Save Seven Hills Ranch
SaveSevenHillsRanch@gmail.com

Subject: Response to the Notice of Preparation for the Environmental Impact Report (EIR) for the Spieker Senior Continuing Care Community Project

County File Numbers: CDGP20-00001, CDRZ20-03255, CDMS20-00007, CDDP20-03018, CDLP20-02838.

PHOTOSIMULATION LOCATION MAP

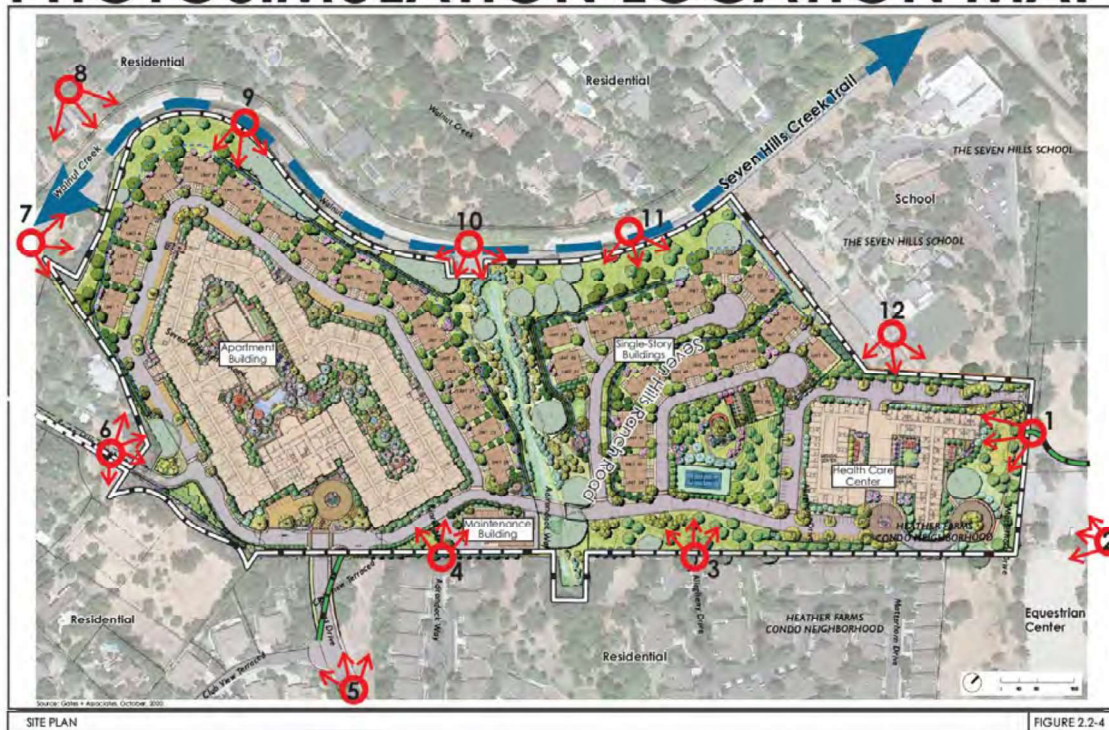
The recommended viewpoint locations are shown here and in the attached “Photosimulation Location Map” and include views from the north, east, south and west of the SHR site. Specifically, these consist of

- **(View 1)** the sidewalk along North San Carlos Drive near the entrance to Seven Hills School
- **(View 2)** the Natural Area on the north side of the parking lot of the Equestrian Center in Heather Farm Park
- **(View 3)** the west ends of Allegheny Drive and **(View 4)** Adirondack Way in the Heather Farms neighborhood
- **(View 5)** from Kinross Drive
- **(View 6)** from the end of Seven Hills Ranch Road where it enters the SHR site at the intersection with Homestead Avenue
- **(View 8)** from the Cherry Street neighborhood to the west
- **(Views 7, 9, 10 and 11)** from the Seven Hills Creek Trail along the western edge of the site along the east side of the Walnut Creek channel
- **(View 12)** from Seven Hills School

View 1

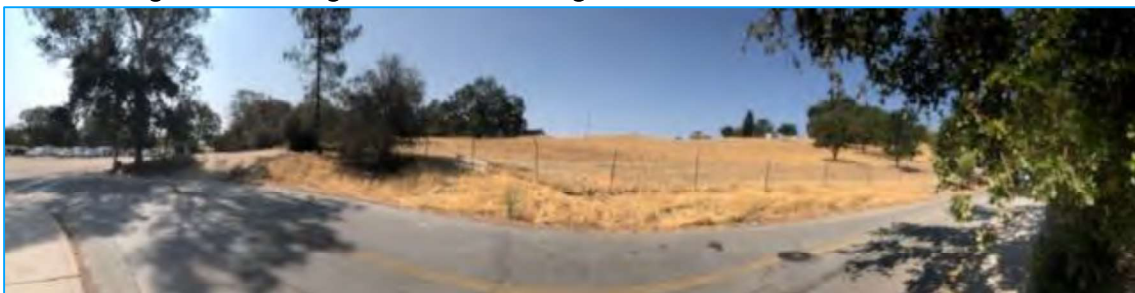
View 1 from North San Carlos Drive in Heather Farm Park – looking south from the sidewalk along the entrance road to Seven Hills School. This view of the SHR site is an essential component of the pastoral setting in the southwestern portion of Heather Farm Park. The undeveloped setting with rolling hills, native oaks and other scatter trees has been a key characteristic of the experience at Seven Hills School, a private school at the end of North San Carlos Drive, which was established at this location in the 1960’s.

The proposed Medical Center, parking lots, access road, and Exclusionary Fence at the boundary of the site, would completely alter this pastoral setting. No information has been provided on the design and height of the security fencing along the northern edge of the SHR site where it borders Heather Farm Park, but it would most likely alter the current open condition, where rural ranch fencing remains along much of the frontage.

View 5

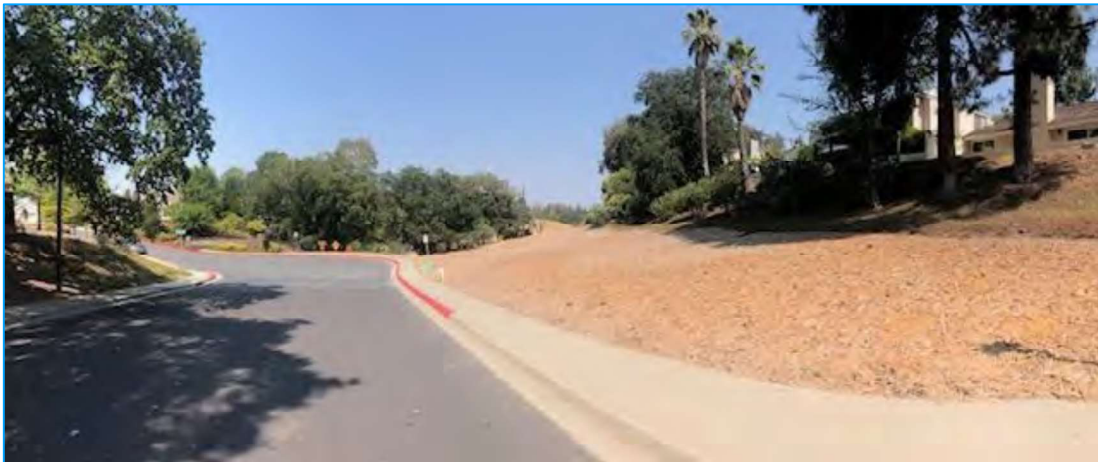
View 5 from Kinross Drive - looking west from Kinross Drive where the main entrance to the Project is proposed. Kinross Drive would be extended directly through the riparian woodland on the far side of the cul-de-sac in this view, rather than the open grassland area to the right.

The Main Building would be highly visible in views from Kinross Drive and Club View Terrace as most of the existing trees that currently screen or occupy the site would be removed. The roof peak of the Main Building would be at an elevation of about 180 feet, an estimated 30 feet higher than the elevation where this particular photograph was taken. The entrance to the building would be two stories, but the four stories that ring the structure would be visible behind, forming a continuous horizon line. The Main Building would occupy most of this view, stretching out of view beyond the hillside at the right edge of the photograph and in line with the single-story residence on the west side of Club View Terrace on the left edge of the image, and higher than the existing tree canopy between these points.

The applicant's Preliminary Arborist Report (by Hortscience/Bartlett Consulting dated July 2020) inaccurately assumes the valley oaks on the south (left) side of the entrance road off of Kinross Drive would be retained. However, the trunks of these trees would be located just a few feet from the new retaining wall and roadway, and construction would so severely affect these trees that they could not survive. These existing trees should therefore not be shown as being retained in the photosimulation as they would inaccurately screen much of the new Main Building in views from this location and closer to the intersection with Club View Terrace.

View 10 *continued*

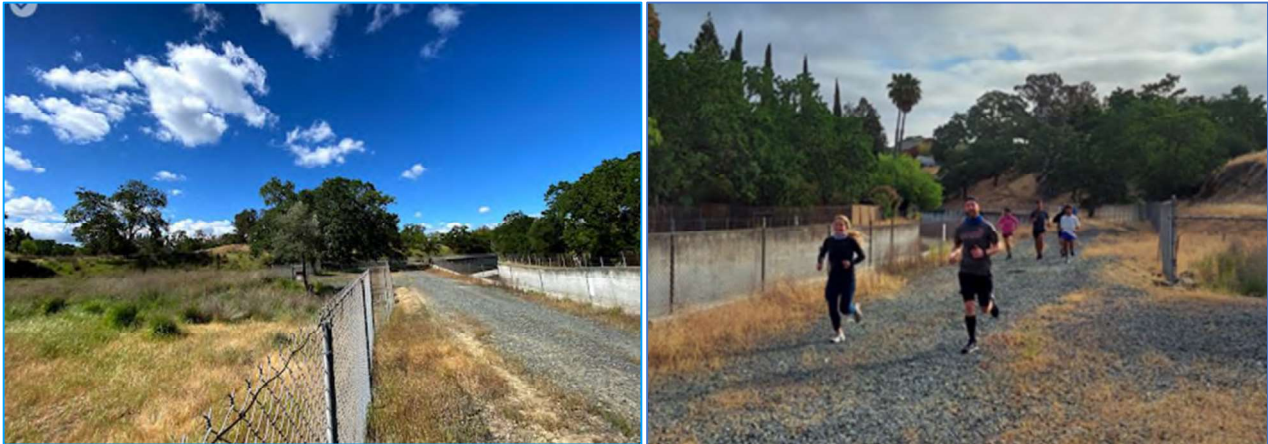
View 10 from Seven Hills Creek Trail – looking east across the center of the SHR site where the perennial stream bisects the property.

Retaining walls up to 26 feet in height would border almost the entire length of the perennial stream under the proposed Project to accommodate the level building pads and buildings of the development. Although the stream would be retained and native species planted along the edge under the proposed project, it would be bordered by vertical walls and new development.

The proposed retaining walls along the central drainage would reach a height of 26 feet across the center of the second photograph, almost to the top of the large oaks (Trees #287, 288, and 291) on the left side of the image. Most of this cluster of valley oaks is shown as being retained in the applicant’s Preliminary Arborist Report, but the proximity of grading within the tree canopy, and construction of the massive retaining walls would adversely affect the root zone of these trees and their long-term survival is uncertain.

Similarly, retaining walls would extend into the root zone of the other specimen oaks along the north (left) side of the drainage (Trees # 370, 359, 357, and 356), with retaining walls in close proximity to the tree trunks, and their long term survival is unlikely. With their decline and eventual death, the continuous retaining wall system in close proximity to these trees would be completely exposed and unscreened in views from Seven Hills Creek Trail and the residences along the west side of the Walnut Creek channel. Effectively screening a retaining wall structure of this kind is unlikely and under best case conditions would take decades before it masked this harsh vertical element. Similarly, views of the massive Main Building could not be effectively screened in views from the Seven Hills Creek Trail in the third and fourth photographs (*next page*) and would permanently alter this beautiful setting on the SHR site.

Figure 1. Regional Faults and Probabilities

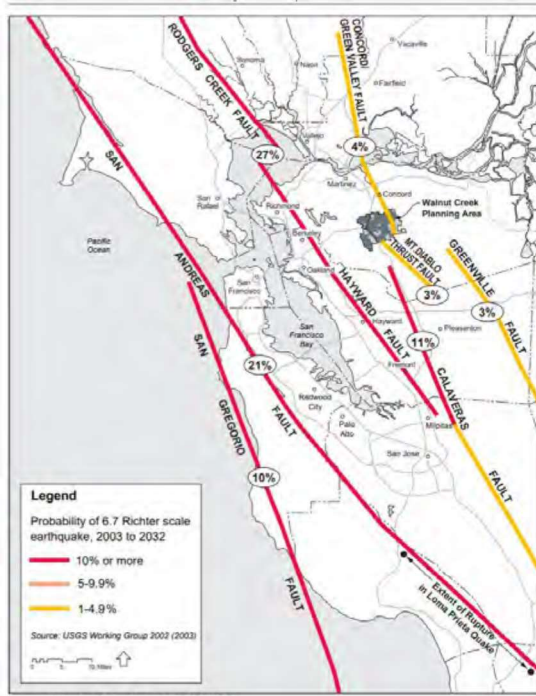
Given the site's nearness to four major earthquake faults - the Mt. Diablo thrust fault, the Concord/Green Valley fault, the Calaveras fault, and the Hayward fault - the EIR should thoroughly and independently study the safety of this site due to its extensive "cut & fill" techniques and retaining walls.

SITE PLAN

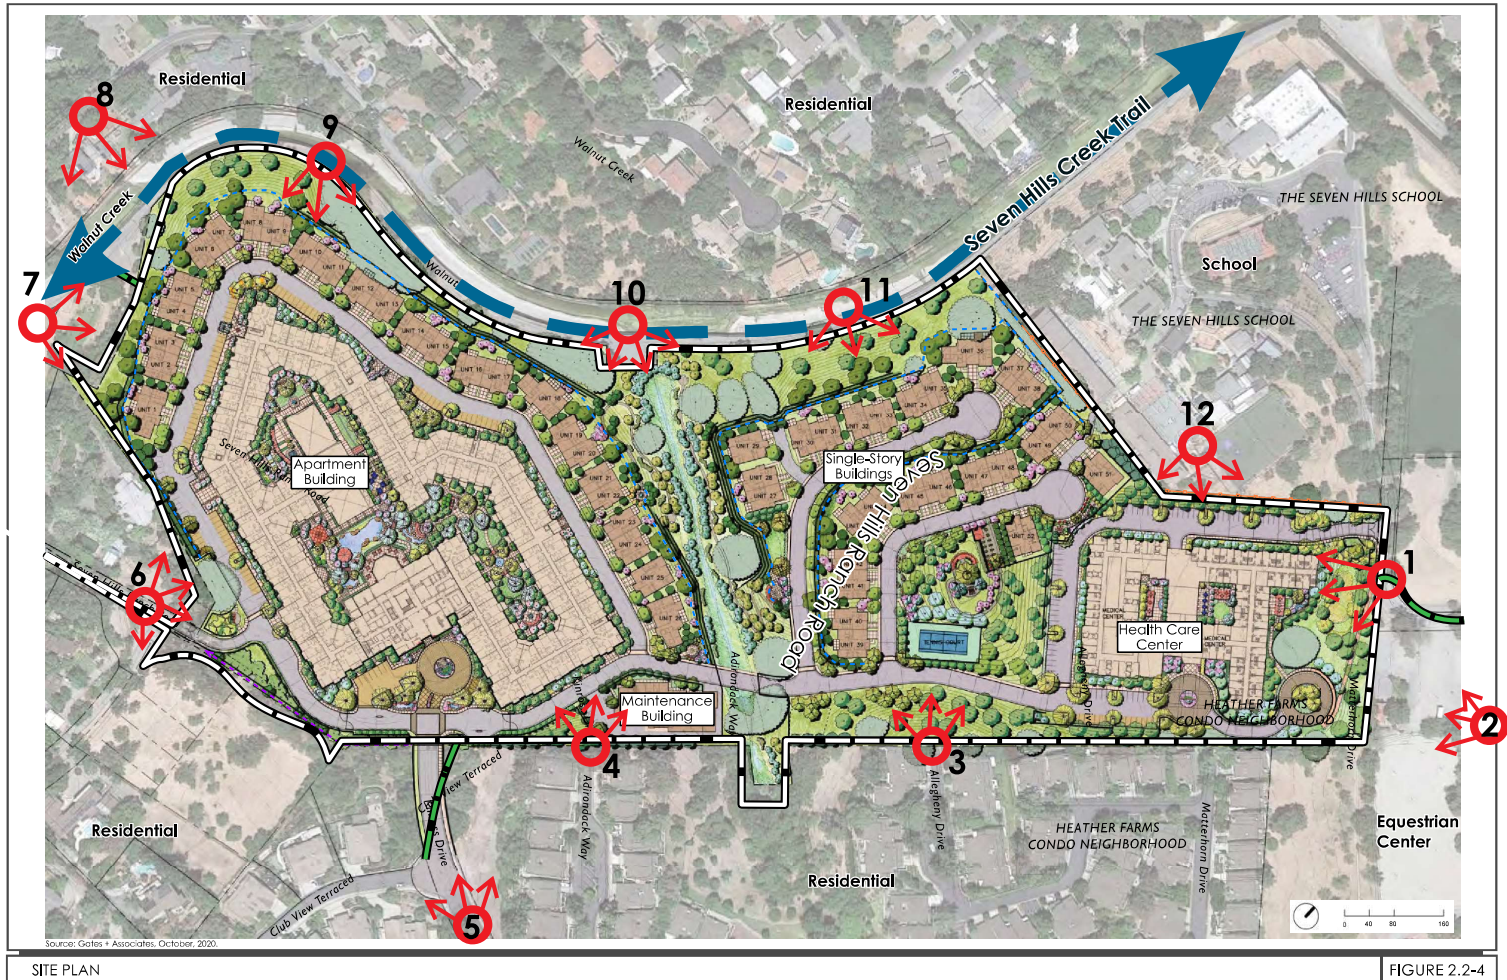
Location of Requested Photosimulations and Direction of View

BIOLOGICAL CONSTRAINTS FOR EIR ALTERNATIVES

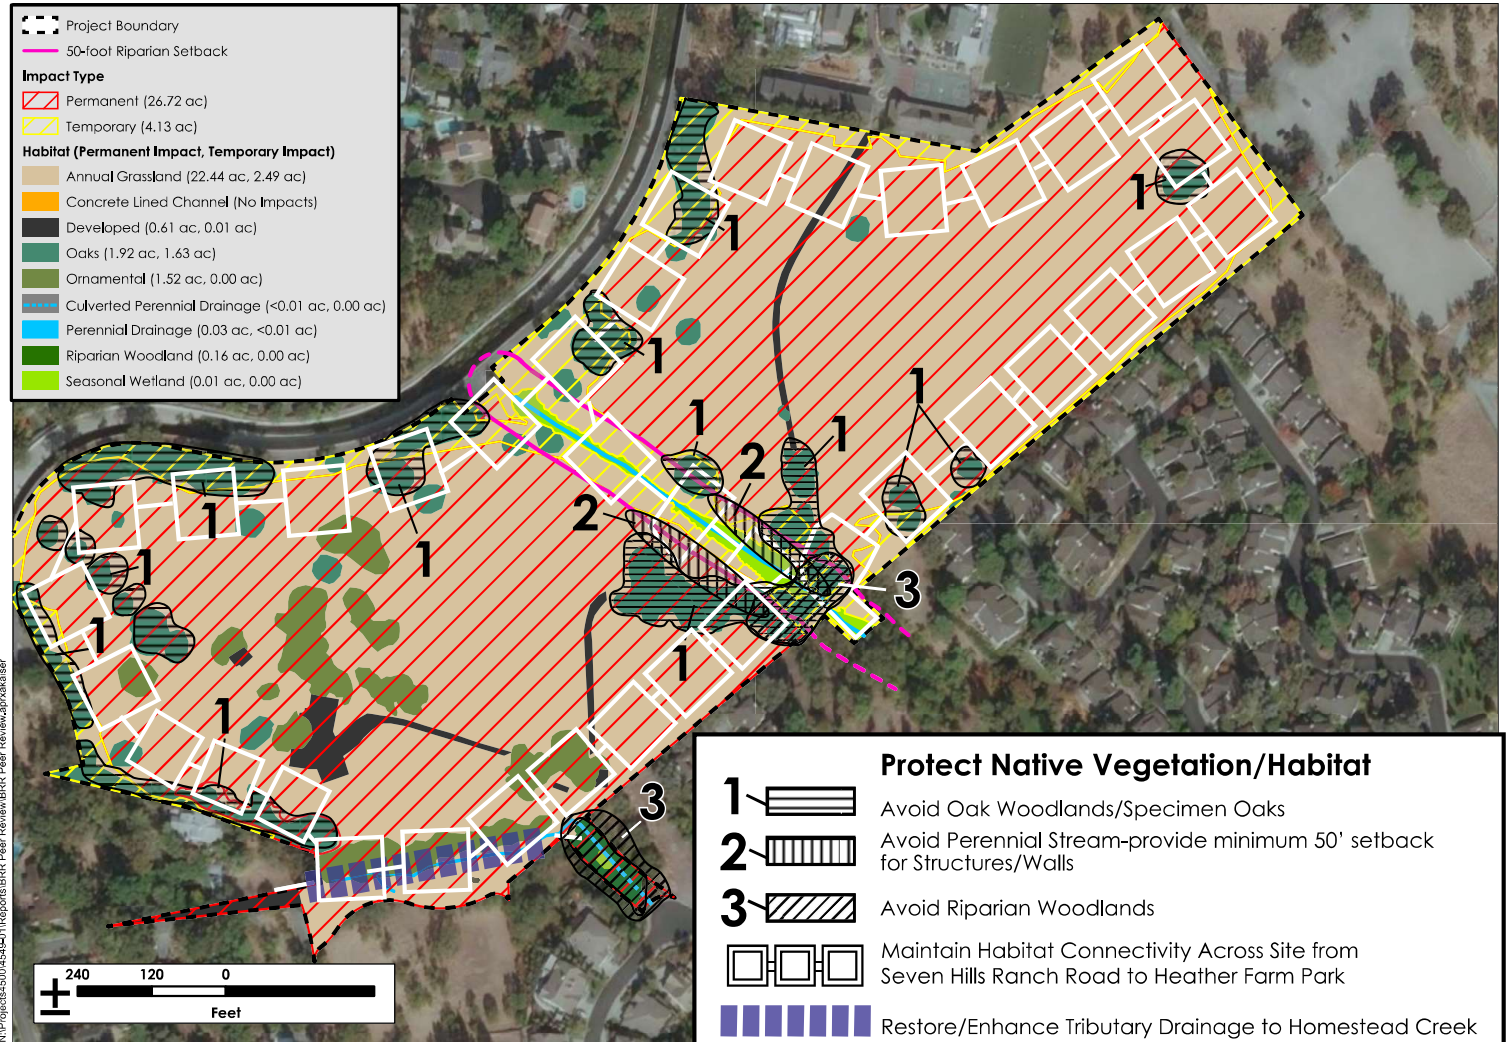
4h. Biological Constraints for EIR Alternatives The shown and attached “*Biological Constraints for EIR Alternatives*” map shows highly sensitive biological features on the SHR site that warrant avoidance and protection. This map is plotted on Figure 2, Impacts Map from the HTH review to show the relationship of known sensitive biological resources to the permanent and temporary impacts of the proposed Project, which in essence encompass the entire site with the exception of the wetlands along the central drainage and a small area around the trunks of specimen oaks to be retained. Additional sensitive biological resources could be identified in the studies recommended above, but the known sensitive resources should be recognized as biological constraints in developing the Environmentally Superior Alternative in the EIR. These known constraints include: 1) avoidance of oak woodlands and protected oaks, 2) providing full avoidance of the perennial stream through the center of the site with a minimum 50-foot setback, 3) avoiding the sensitive riparian woodlands, 4) maintaining wildlife habitat connectivity and movement opportunities across the site, and 5) restoring and enhancing the tributary drainage to Homestead Creek along the southeastern boundary of the site. The proposed Project currently completely disregards each of these sensitive biological resources as indicated in the extent of permanent and temporary impacts mapped in the HTH review, essentially eliminating all of these features from the SHR site. Unfortunately, the HTH review does not include any mitigation measures to address these substantial and significant adverse impacts, which must be provided in the EIR. This is warranted to ensure compliance with applicable State and federal regulations and consistency with the County and City of Walnut Creek General Plans and ordinances.

-  Break up Mass and Footprint, and Reduce Height of Massive Structures
-  Protect Native Trees/Woodland (see Biological Constraints for Alternative Map)
-  Eliminate Massive Retaining Walls up to 26' in Height and Replace with Natural Slopes
-  Implement Bike/Ped Trail Corridor Across Site from Walnut Creek General Plan
-  Retain more of Natural Form of Highest Knoll on Site
-  Accommodate Future Restoration of Walnut Creek under Adopted 2009 CCCFCD Plan - by removing antiquated concrete channel wall and restoring east bank as vegetated natural habitat.
